UNITED STATES  
DEPARTMENT OF THE INTERIOR  
BUREAU OF LAND MANAGEMENTFORM APPROVED  
OMB NO. 1004-0137  
Expires: January 31, 2018**SUNDRY NOTICES AND REPORTS ON WELLS**  
*Do not use this form for proposals to drill or to re-enter an abandoned well. Use form 3160-3 (APD) for such proposals.*5. Lease Serial No.  
NMNM107369

8. Well Name and No.  
HH CE 26 23 FED 001 4H9. API Well No.  
30-015-45426-00-X110. Field and Pool or Exploratory Area  
PURPLE SAGE-WOLFCAMP (GAS)11. County or Parish, State  
EDDY COUNTY, NM**SUBMIT IN TRIPLICATE - Other instructions on page 2**1. Type of Well  
☐ Oil Well ☒ Gas Well ☐ Other2. Name of Operator  
CHEVRON USA INCORPORATED  
Contact: LAURA BECERRA  
E-Mail: LBECERRA@CHEVRON.COM3a. Address  
6301 DEAUVILLE BLVD  
MIDLAND, TX 797063b. Phone No. (include area code)  
Ph: 432-687-7655

Chevron respectfully requests the following changes to the approved APD as referenced in the attached supporting documents.

(Change of well name)From: HH CE 26 23 FED 001 4H  
To: CICADA UNIT 19H

**WELL PLAT**

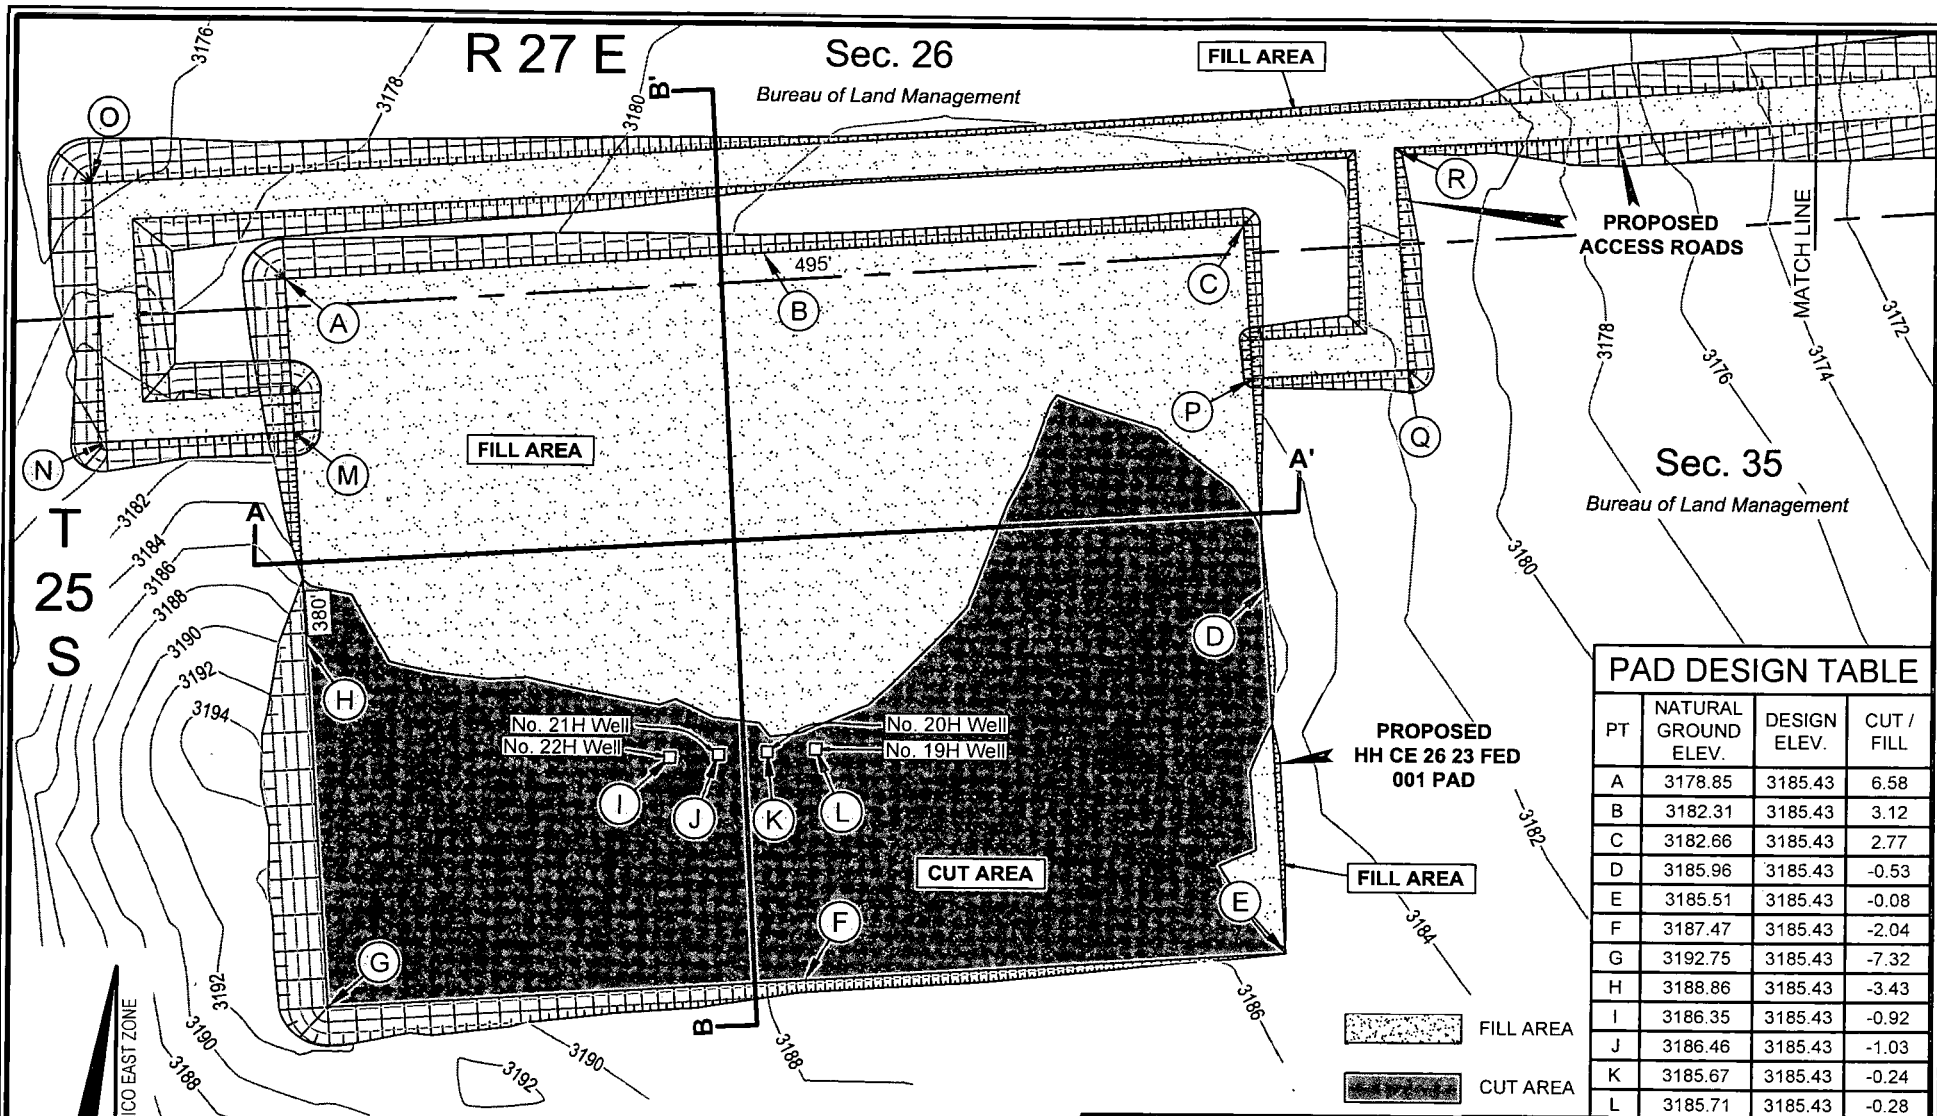
(Change of pad size), revised well plat and cut & fill pat are attached.
